## Product/Process Change Notice (PCN)

PCN #: WE\_PD3\_20170616

Product Affected: WE-PD3 size S series

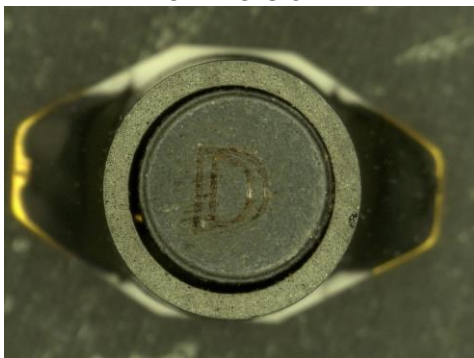
To increase the production capability, the product marking of the WE-PD3 Type S will be changed from Pad printing to Laser Marking.

- 1.) All electrical and mechanical properties of the parts will remain the same.
- 2.) Laser -Marking will replace the pad printing method.
- 3.) Marking appearance:
